RE: North Penn High School BP-2
Change Order Request #28 ASI #3 – Courtyard Revisions

Architect's Supplemental Instructions

ARCHITECT'S SUPPLEMENTAL INSTRUCTIONS (ASI) 03
COURTYARD AND AREA B EQUIPMENT YARD

ASI#3 -Courtyard Grading and Drainage Revisions

Drawing Title:
GRADING PLAN - A

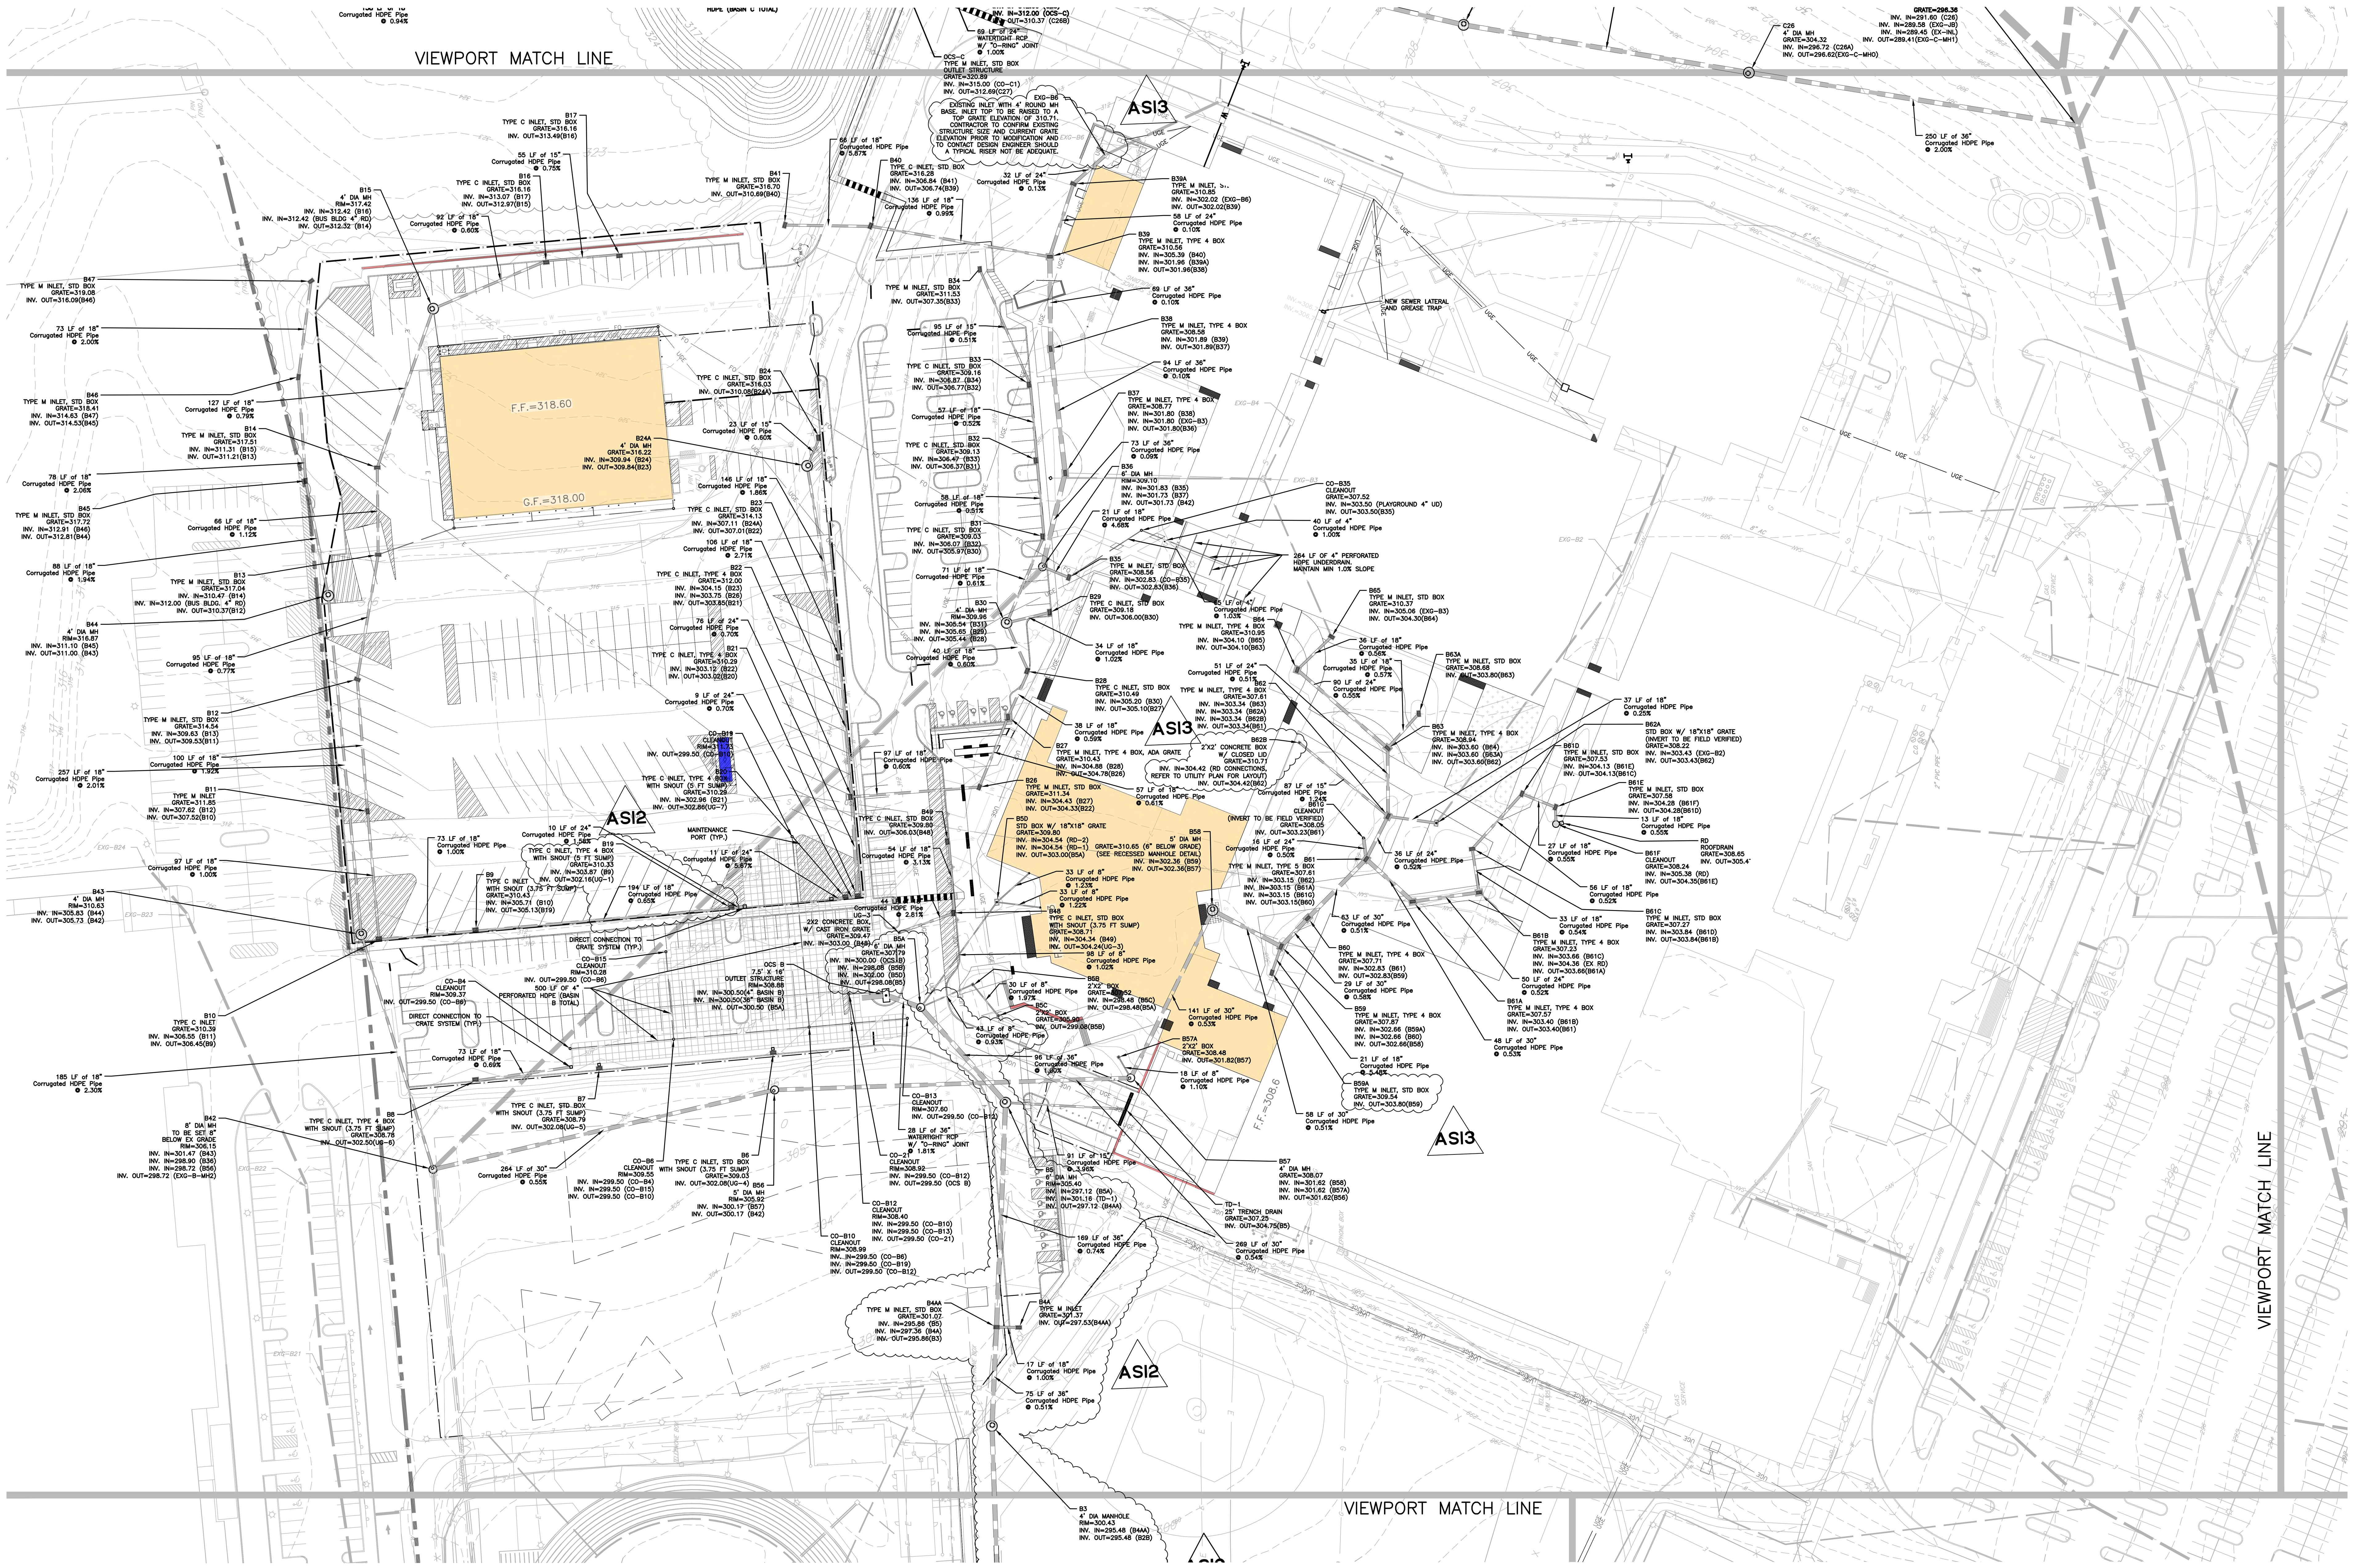
2. Grading Plan A (BP2-C012) has been modified to make plan revisions including but not limited to:
    - **To revise courtyard grading to ensure ADA compliance and proper connection between finish floor elevations at building door locations**
    - **To revise grades in Area B Equipment Yard to allow proper drainage**

Drawing Title:
DRAINAGE PLAN - A

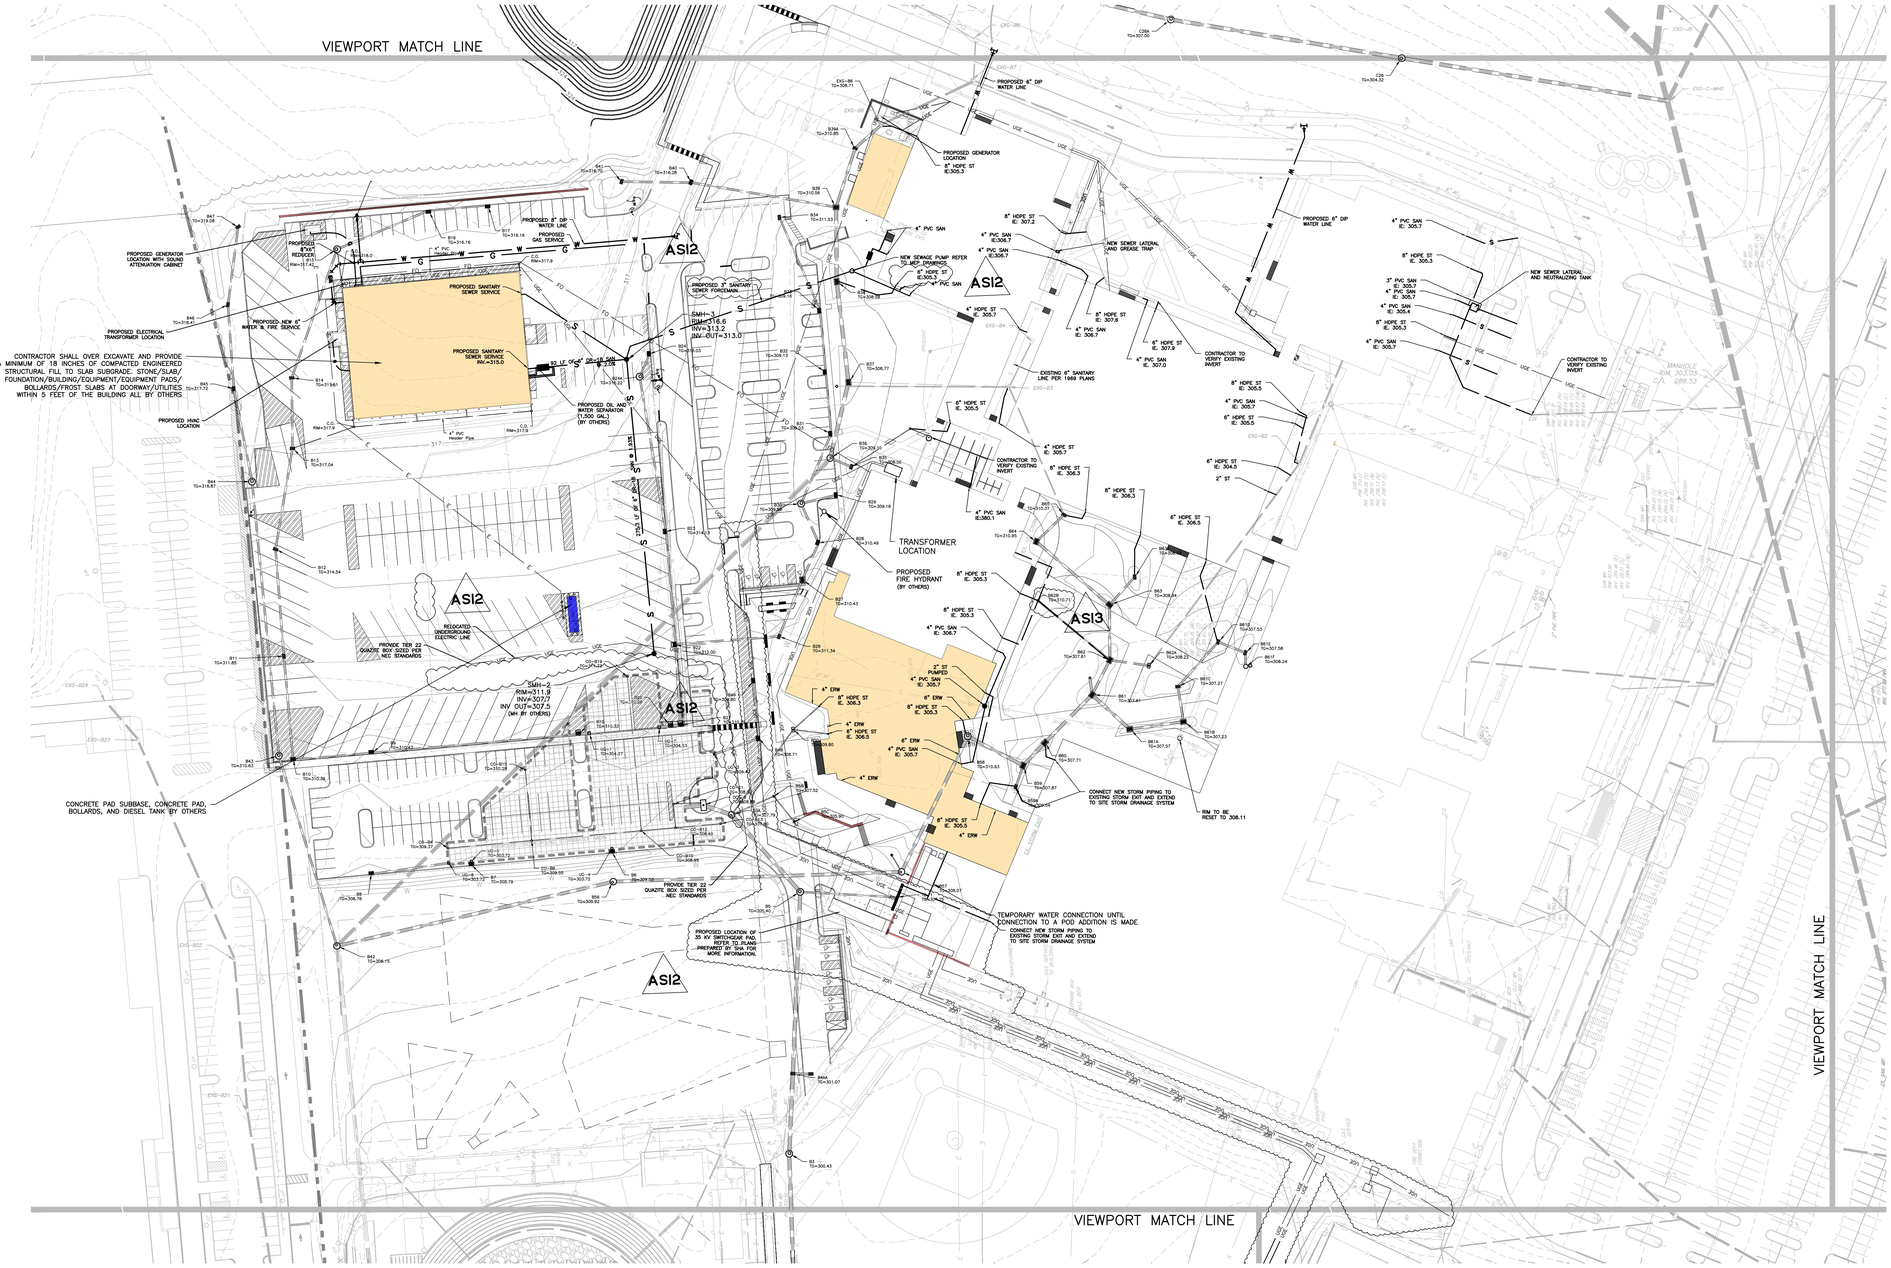
3. Drainage Plan A (BP2-C017) has been modified to make plan revisions including but not limited to:
    - **To add 2'x2' structure B62B to the courtyard storm network to connect roof drains to structure B62.**
    - **To raise B59A by 1' to work with revised courtyard grading. This will not affect the structure's shop drawing.**

- **To raise the existing inlet in Area B Equipment Yard to allow proper drainage**

Drawing Title:
COURTYARD DETAILED PLAN

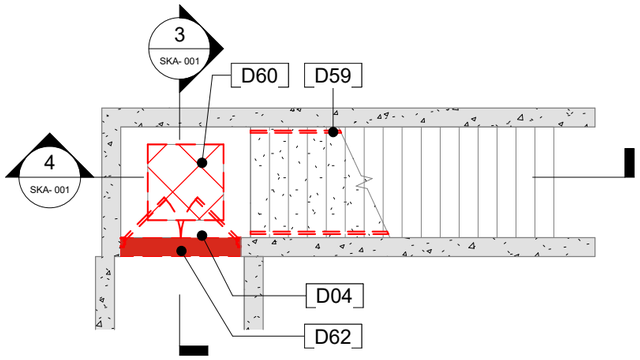
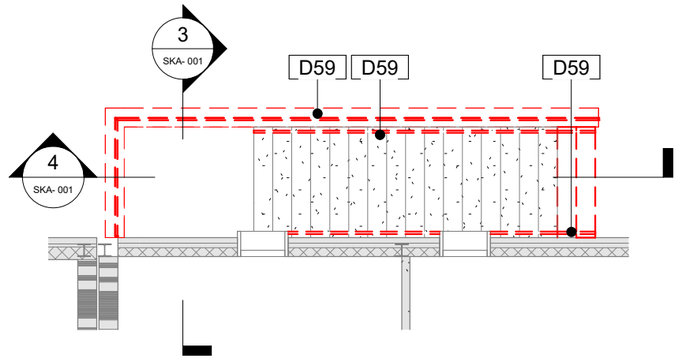
5. Courtyard Detailed Plan (BP2-C039) has been modified to make plan revisions including but not limited to:
   - **To revise proposed courtyard hardscape footprint and retain existing generator.**
   - **To revise extents of concrete path near the Southwest entrance(s) to the interior courtyard.**

Drawing Title:
EXTERIOR STAIR DEMOLITION

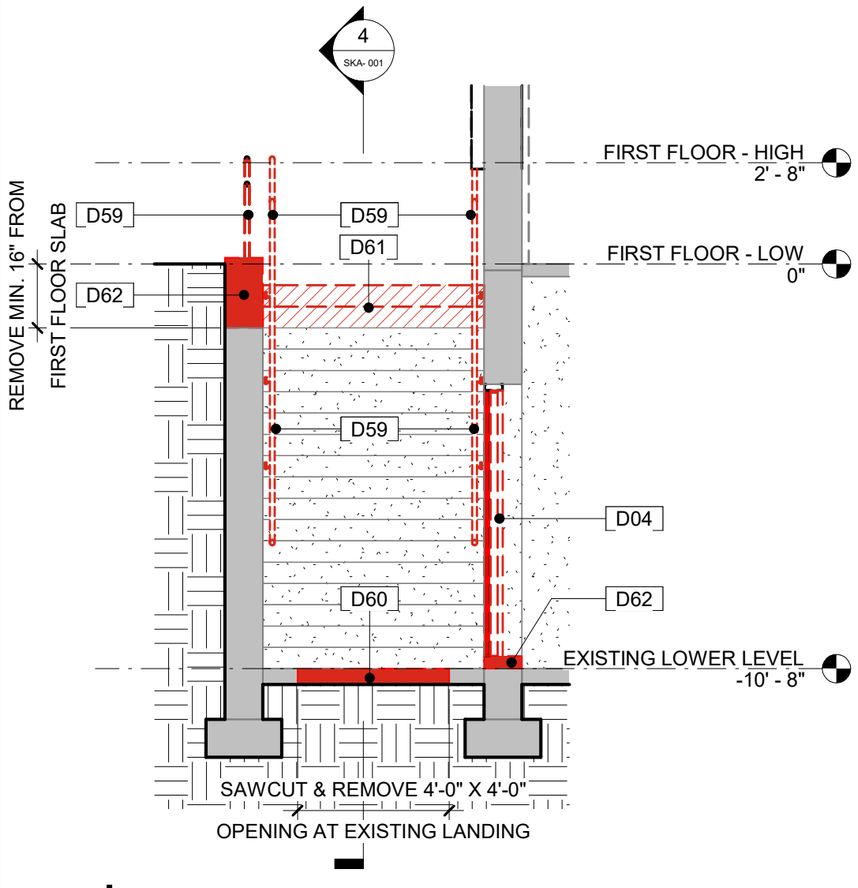
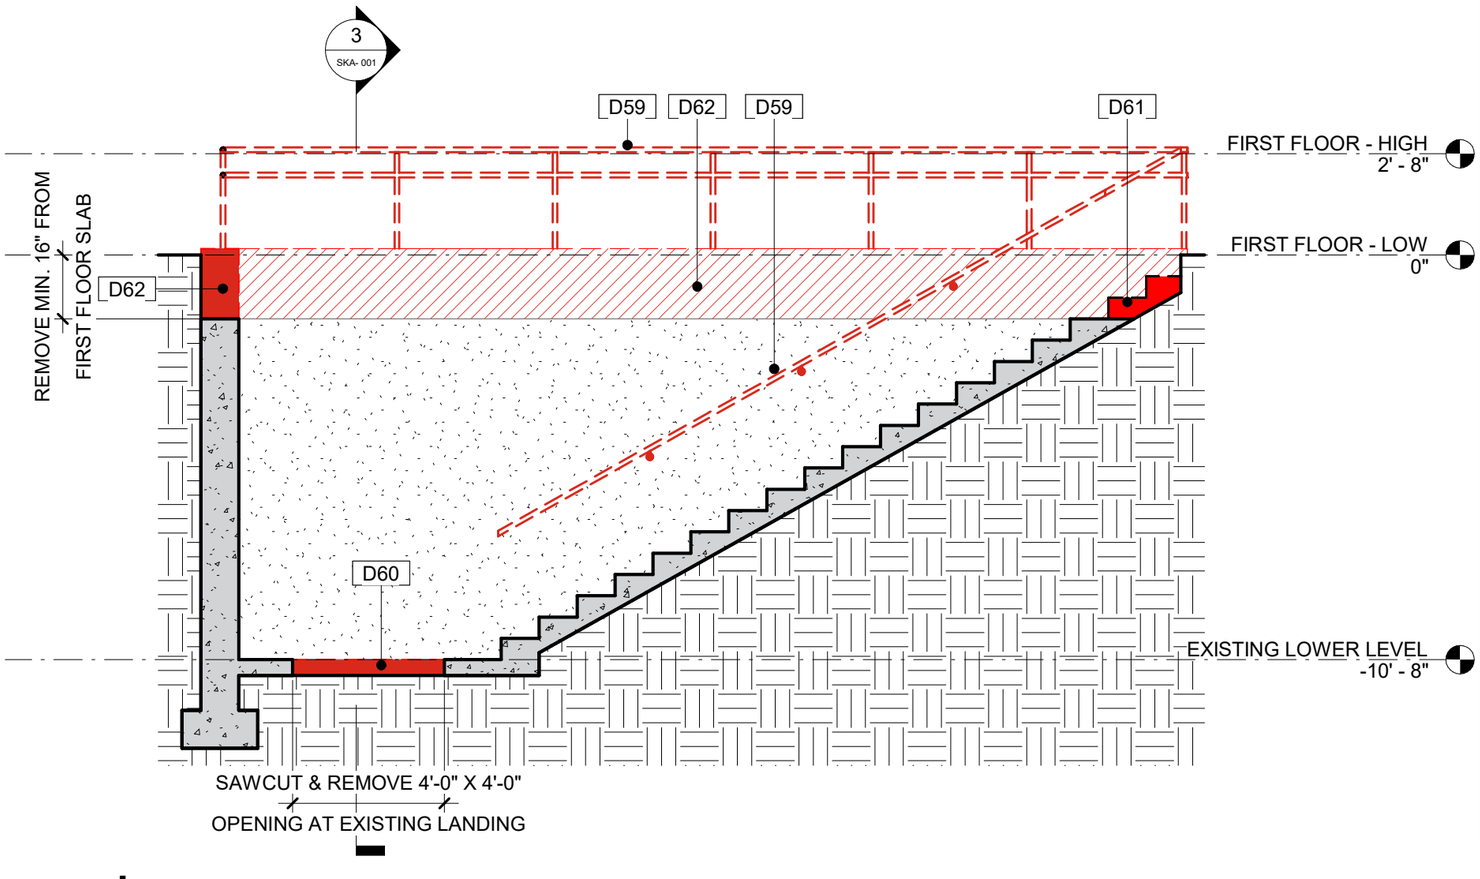
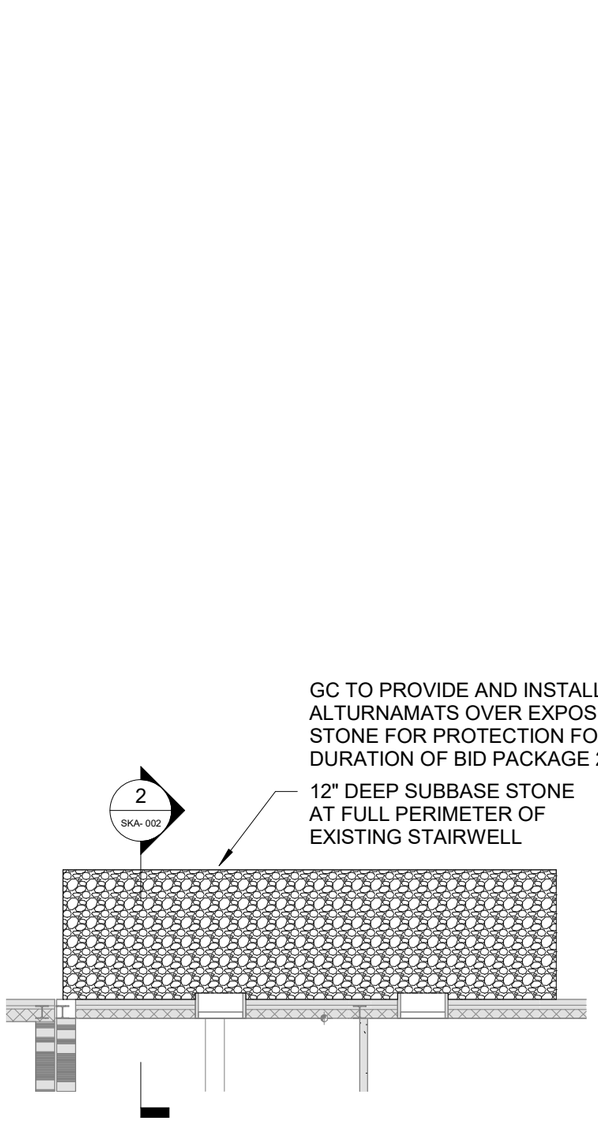
EXTRA WORK/CHANGE DESCRIPTION:
Hammer Steps and Wall below grade, leave in place to be buried. Hammer bottom of stairs to allow drainage.
NO MATERIAL WILL BE REMOVED FROM SITE. BACKFILLING OF STAIRS IS NOT INCLUDED IN THIS PRICE
NO SAW CUTTING IS INCLUDED. Surface will be rough as they will be broken off and not neatly removed.

DEMOLITION KEY - EXTERIOR STAIR	
KEY VALUE	KEYNOTE TEXT
D59	REMOVE EXISTING HANDRAIL/GUARDRAIL IN ITS ENTIRETY.
D60	REMOVE PORTION OF EXISTING SLAB AS INDICATED IN DRAWING.
D61	REMOVE PORTION OF EXISTING CONCRETE STAIR AS INDICATED IN DRAWING.
D62	REMOVE PORTION OF EXISTING CONCRETE WALL AS INDICATED IN DRAWING.

Drawing Title:
EXTERIOR STAIR INFILL

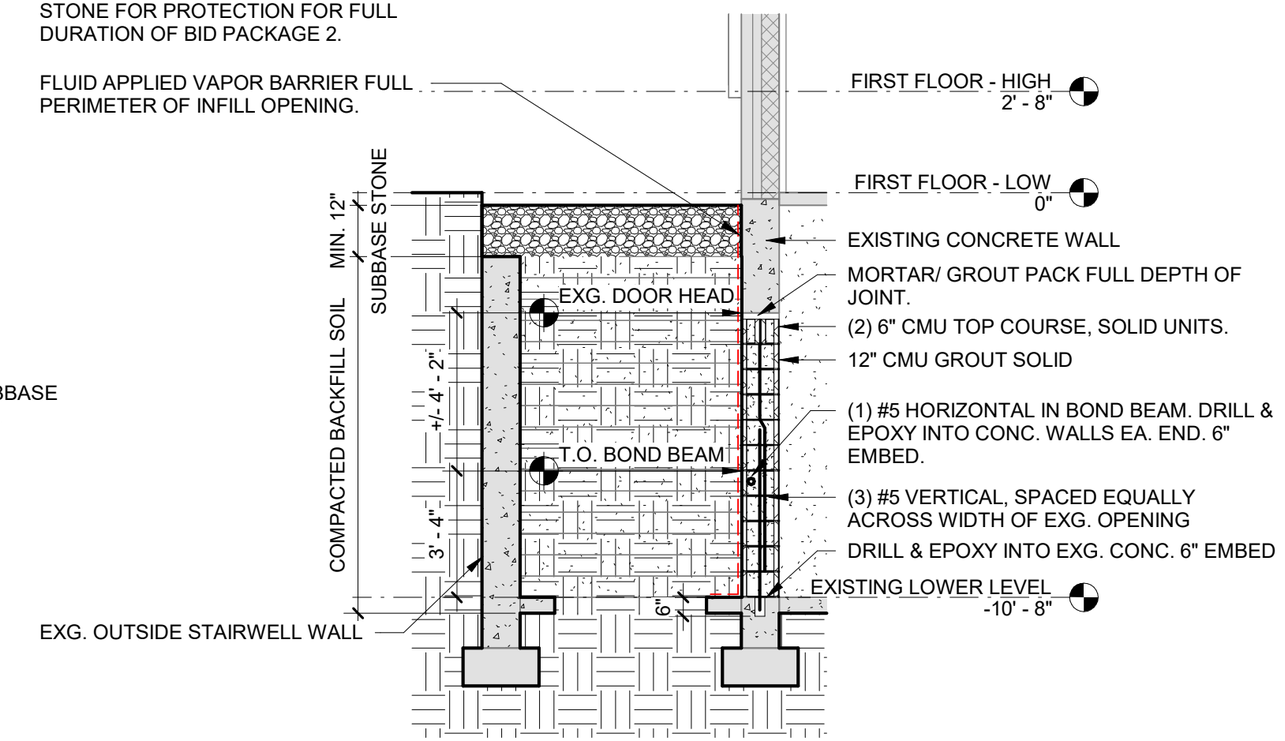
This will confirm my price of NINE HUNDRED TWENTY HUNDRED DOLLARS ($920.00) for the waterproofing of the stairway enclosure at the above stated school. This price includes waterproofing and drainage/protection board.

SCOPE	Cost
	INCLUSIONS: All labor, material, and equipment to complete the described work below. Exterior stair infill per BP2- SKA- 002 12" CMU grouted solid with 1 bond beam course, rebar drilled and epoxied into the footer. Drill and epoxy rebar into Jambs. 6" CMU at top of wall. Clean up Good access to all work areas is figured in this estimate Equipment and scaffolding as required **EXCLUSIONS:** Bonds, Permits, Testing, Inspections, Engineering, Layout, Surveying and Drawings Lawn and shrubbery repair/landscaping Power, water and adequate lighting on site (provided by others) Union Labor and Prevailing Wages Winter Conditions Costs associated with powerlines **ALTERNATES:** **ADD: $ -** **DEDUCT: $ -**	**$3,965.00**
Pages 1 & 2 are mutually indispensable.	Total	**$3,965.00**

GC TO PROVIDE AND INSTALL
ALTURNAMATS OVER EXPOSED SUBBASE
STONE FOR PROTECTION FOR FULL
DURATION OF BID PACKAGE 2.

FLUID APPLIED VAPOR BARRIER FULL
PERIMETER OF INFILL OPENING.
